MOLA
Architecture

Tandy's Lane Phase 2

Planning Ref no. SDZ 22A / 0006

In response to Planning Conditions 13 and 21

MOLA CONDITION 13 A v

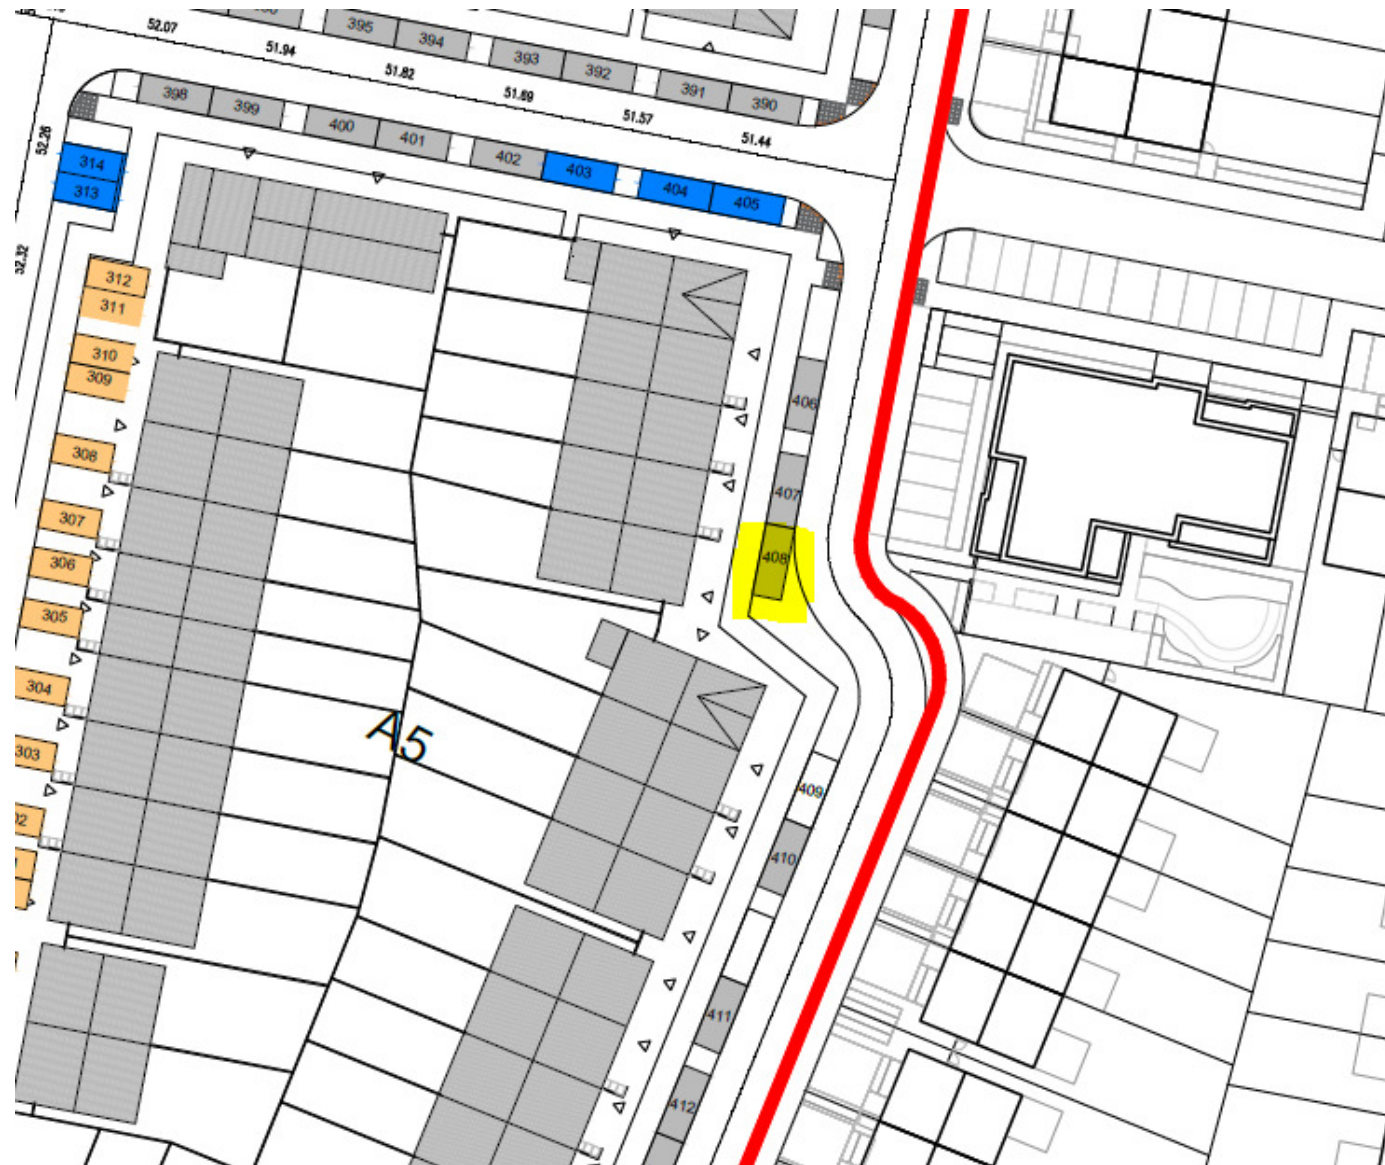
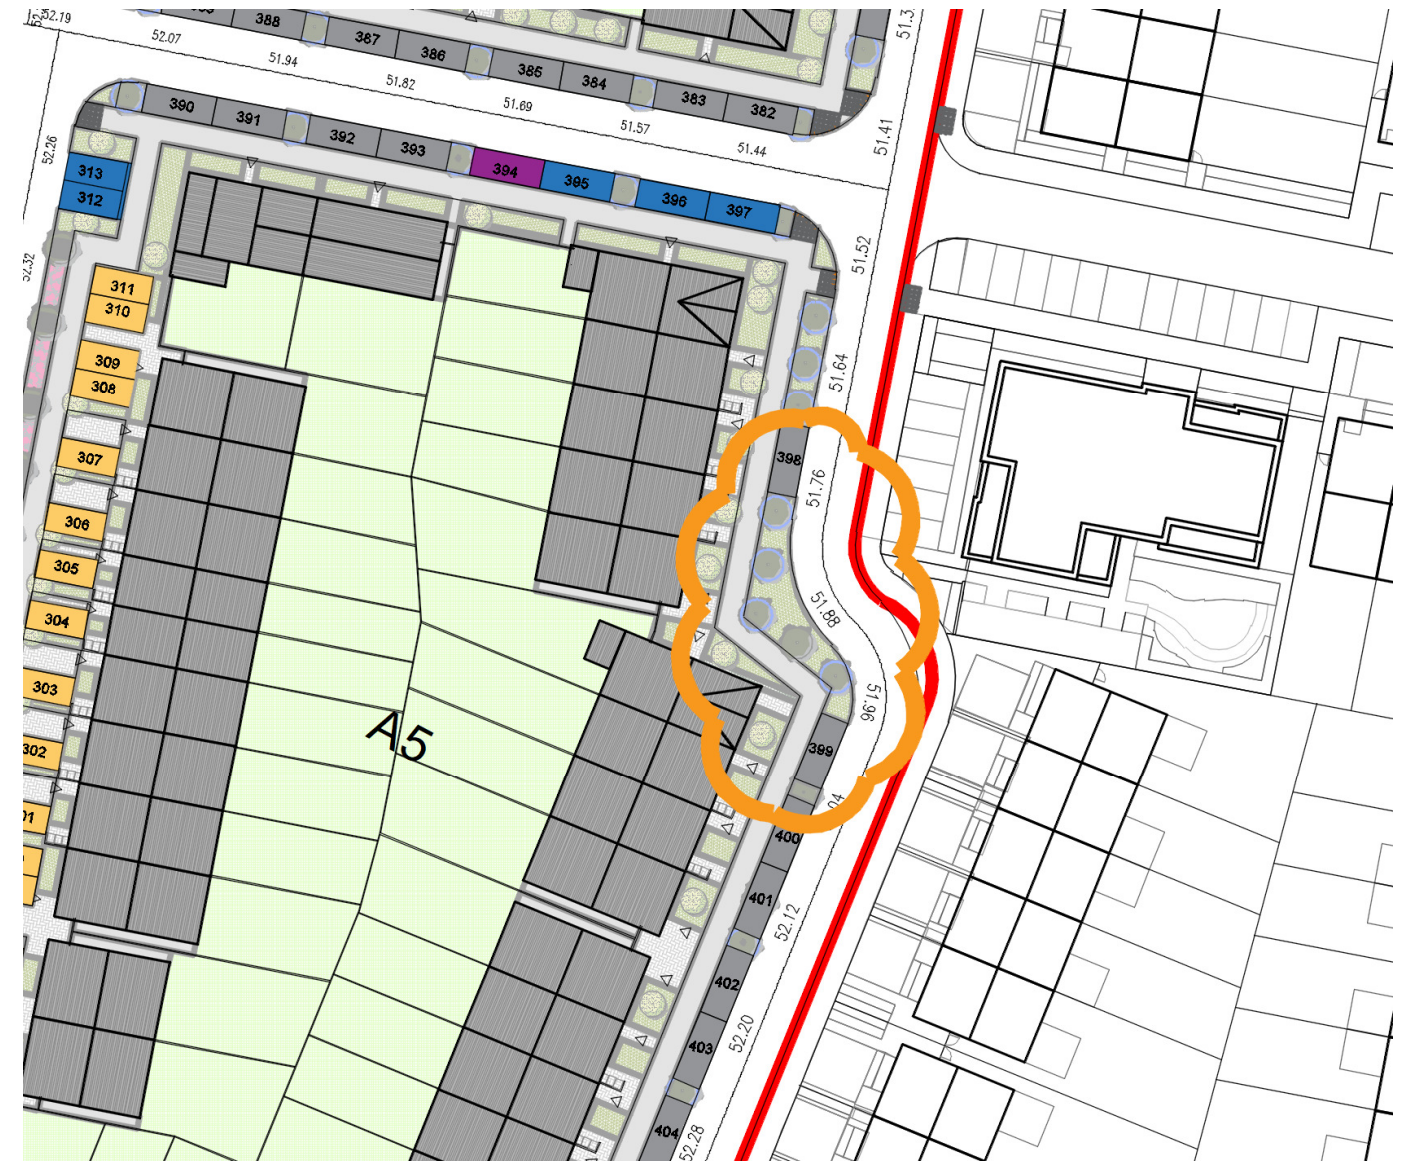
v. Details of refuse collection areas as raised in the submitted Road Safety Audit and any other safety issues raised. Car parking space no. 408 shall be revised so that it would be

Response to 13 (a)(v): Car parking space previously numbered as no. 408 is now relocated. Due to revisions to parking across the site since the RFI submission drawings including additional accessible spaces, the parking numbering has been revised throughout. The new location for the space previously numbered as no. 408 is now car parking space no. 399 and subsequent car parking spaces have been relocated further South as required.

MOLA CONDITION 21 A

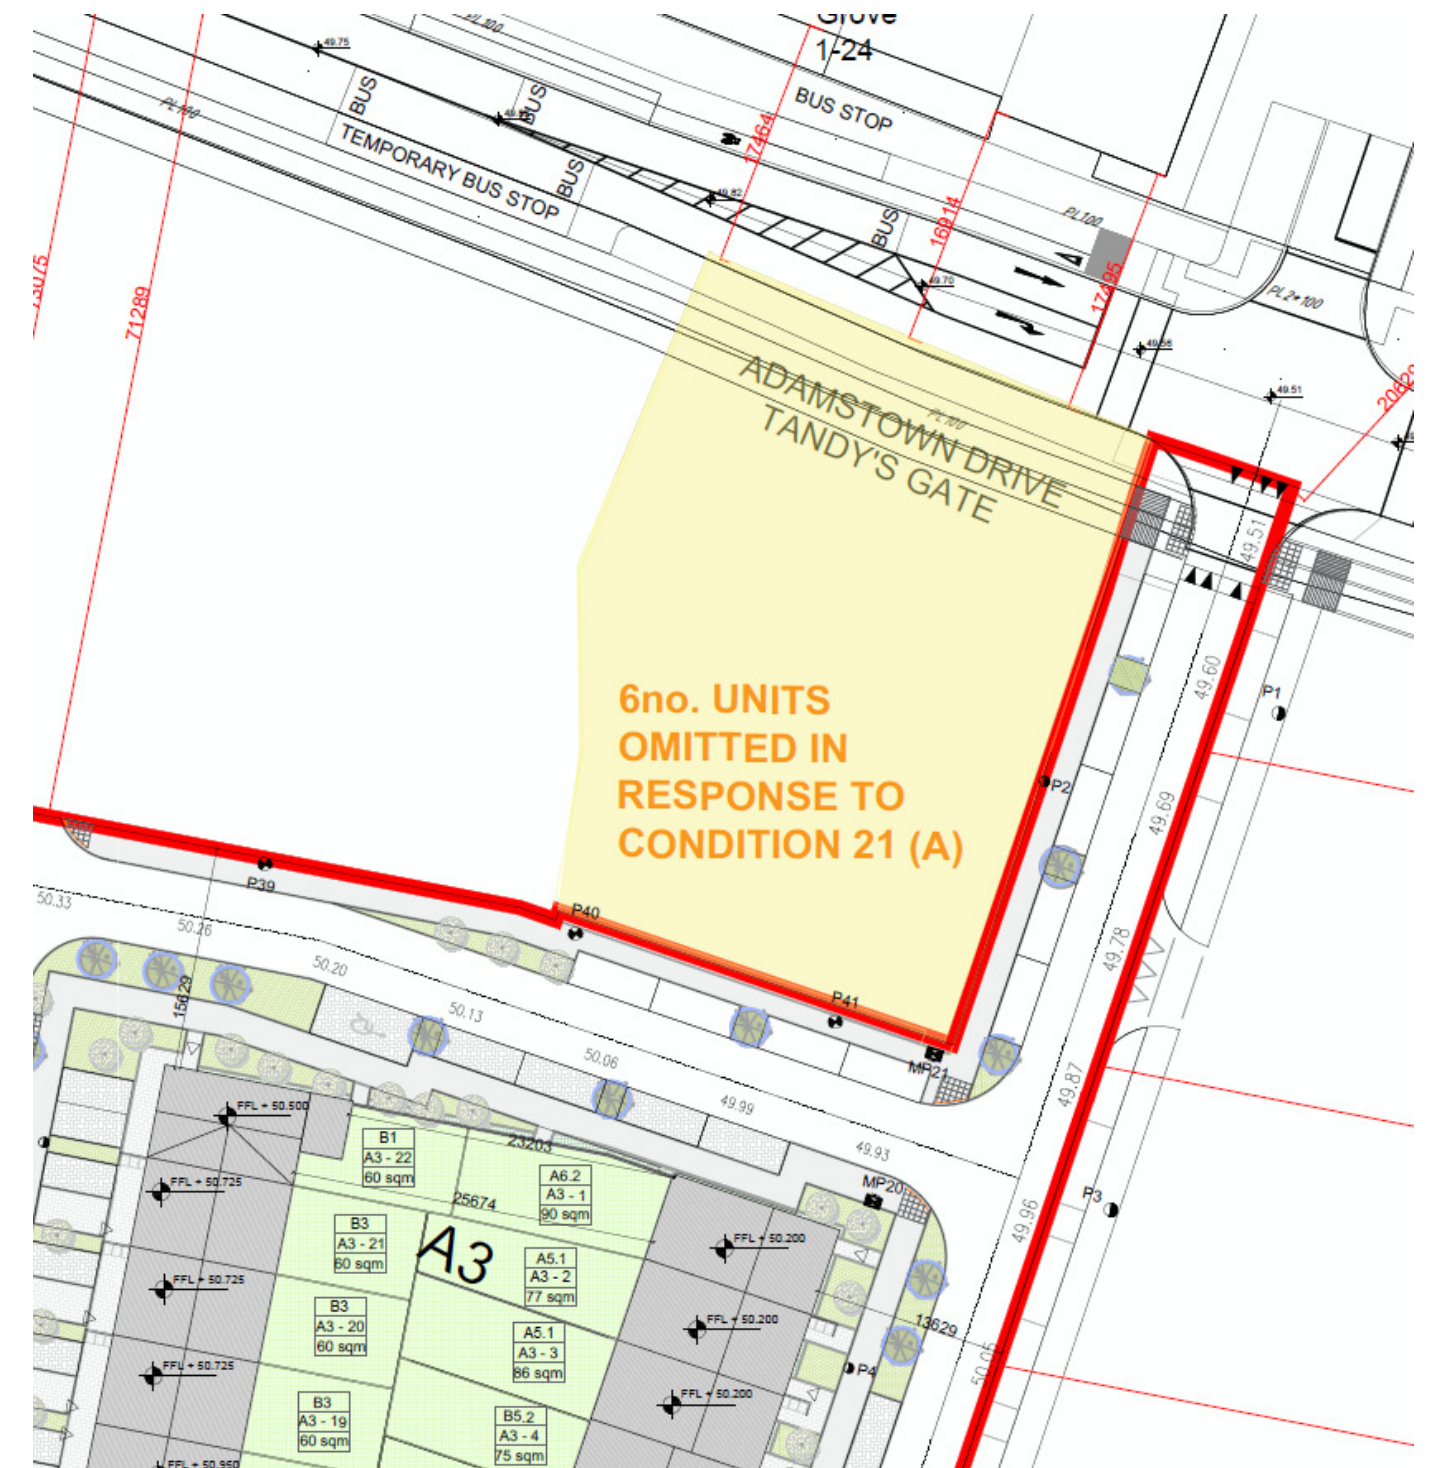
(a) Omit Units A3-1 to A3-6 inclusive (6 no. units in total) and this area incorporated into any forthcoming application for the remaining lands of Development Area No. 6 Tandy's Lane Village.

Response to 21 (a): Units A3-1 to A3-6 inclusive are omitted and red line boundary is revised. Please refer to drawings 0100 and 0100A. Please also refer to revised Schedule of Accommodation for the revised unit numbers and revised site statistics and density.

REVISION IN
RESPONSE TO
CONDITION 21 (B)

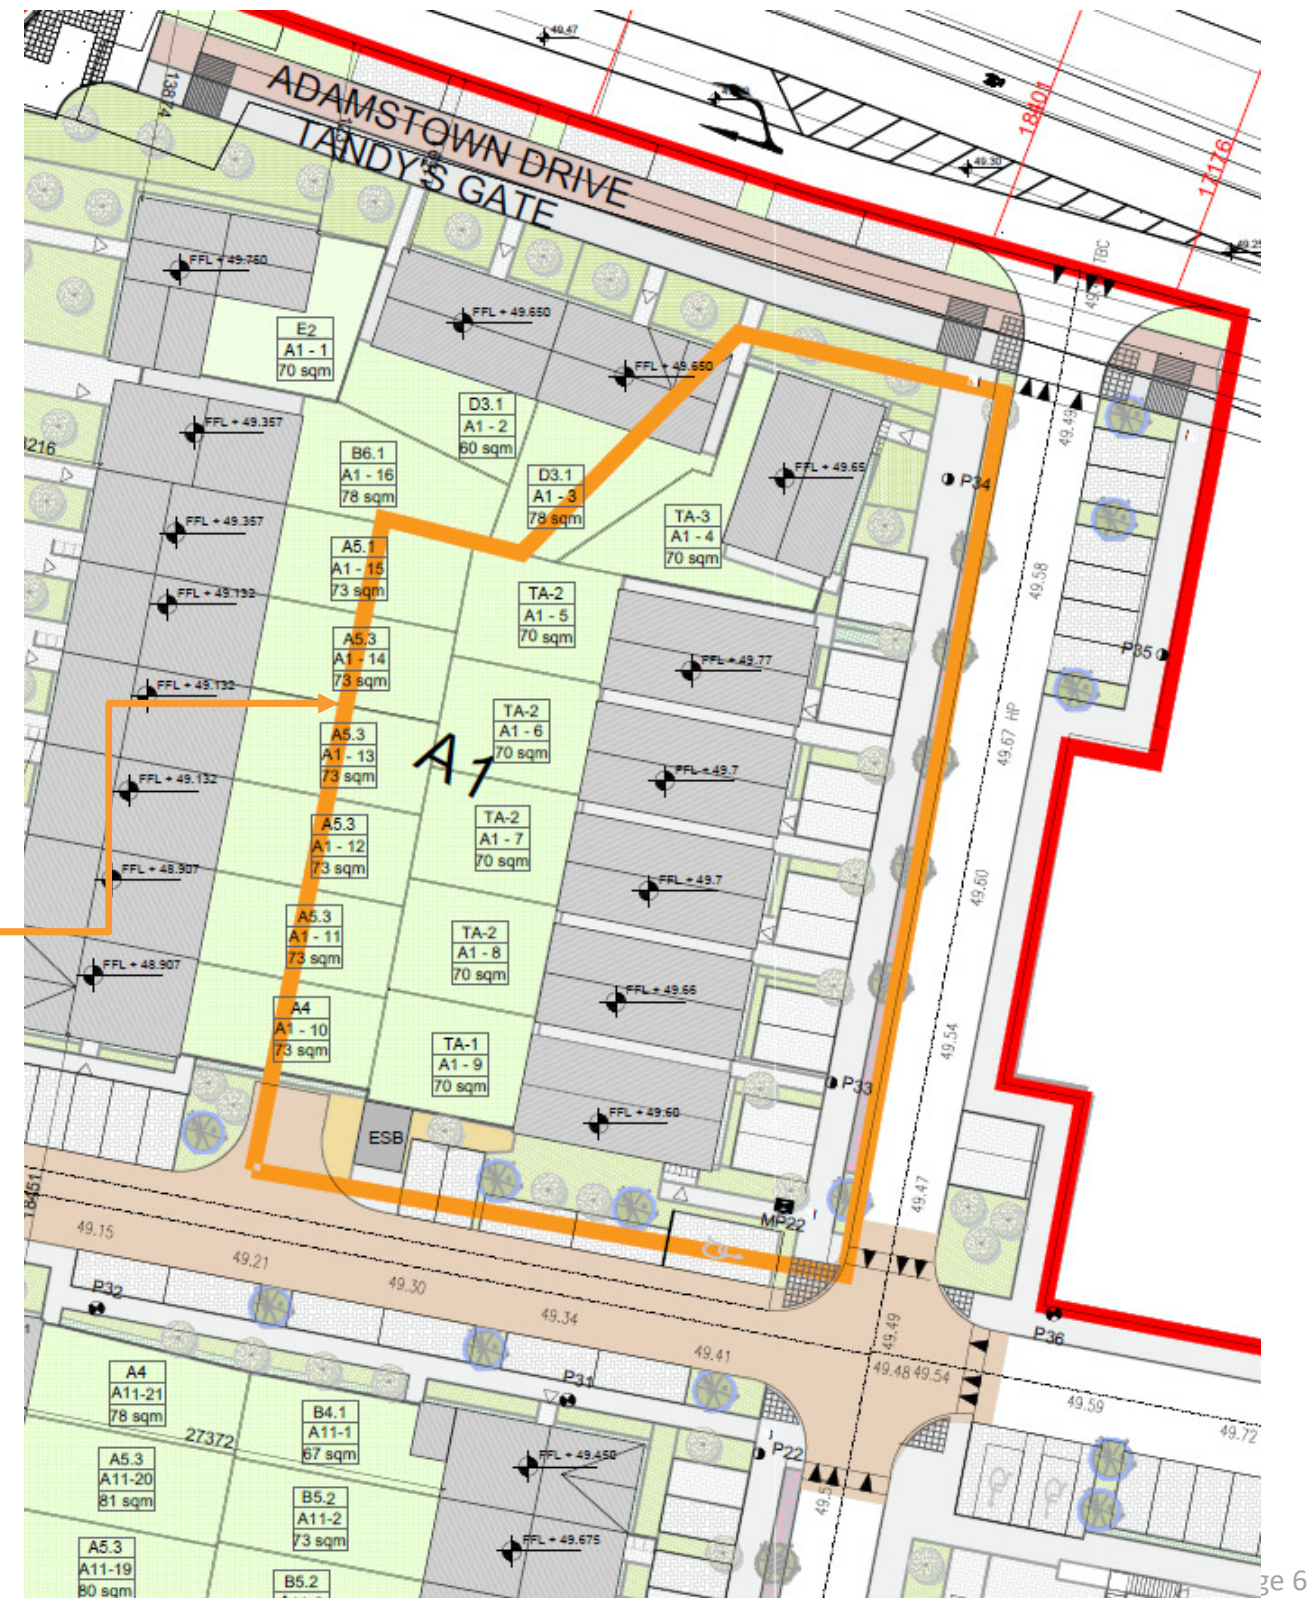
(b) The private amenity spaces for Units A1-4 to A1-9 inclusive (6 no. units in total) shall be increased in size to provide for the minimum private amenity space requirement of 70sq.m for a four bedroom house under the Adamstown Strategic Development Zone Planning Scheme 2014 (as amended).

Response to 21 (b): The private amenity spaces for Units A1-4 to A1-9 inclusive is increased to 70sq.m. Please refer to drawings 0100 and 0100A.

2NO. 3 BED UNITS (UNIT TYPE B5.1) OMITTED AND REPLACED WITH 1NO. A5.1 UNIT

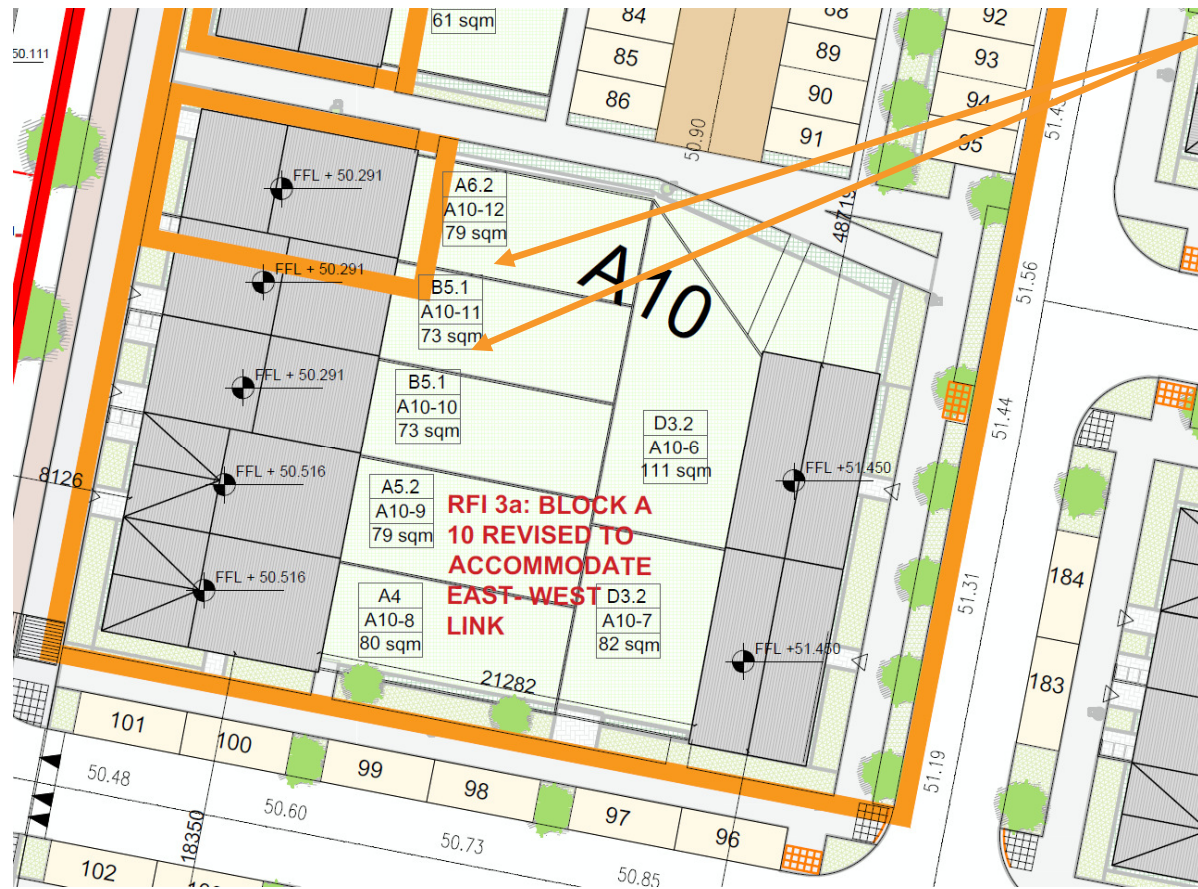
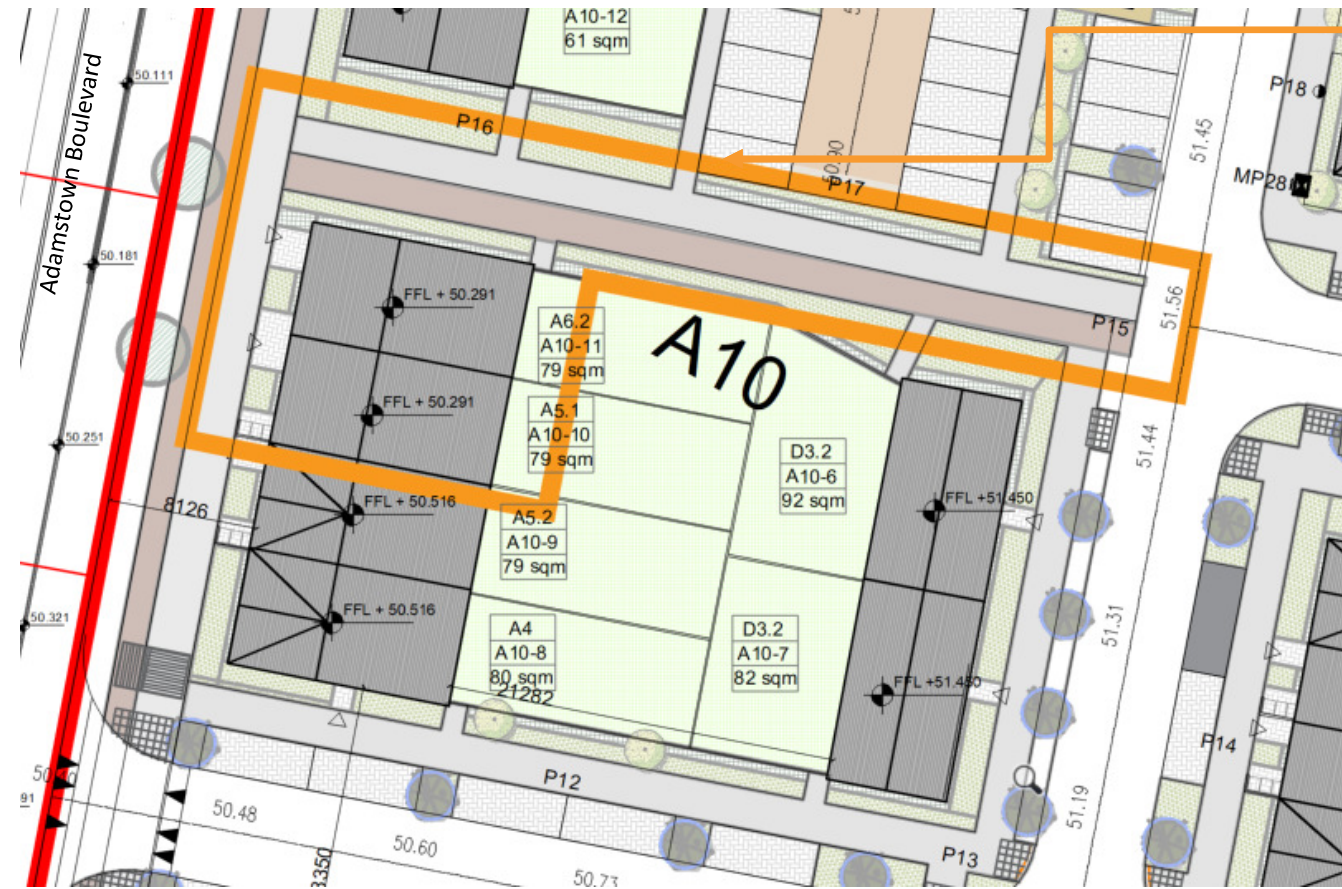
(c) The southern east-west pedestrian connection revised to include cyclist access to Adamstown Boulevard from the site.

Response to 21 (c): The southern east-west pedestrian connection is revised to include cyclist access to Adamstown Boulevard from the site. This block has been reduced by one unit in total - 2no. 3 bed units (Unit type B5.1) which are 2 storey were omitted and 1no. 4 bed unit (Unit Type A5.1) which is 3 storey included to achieve the gap needed for a pedestrian/ cyclist link. Please refer to drawings 0100 and 0100A. Please also refer to revised Schedule of Accommodation for the revised unit numbers.

* A5.1 Unit included at plot A10-10 to maintain 3 storey contiguous elevation along Adamstown Boulevard
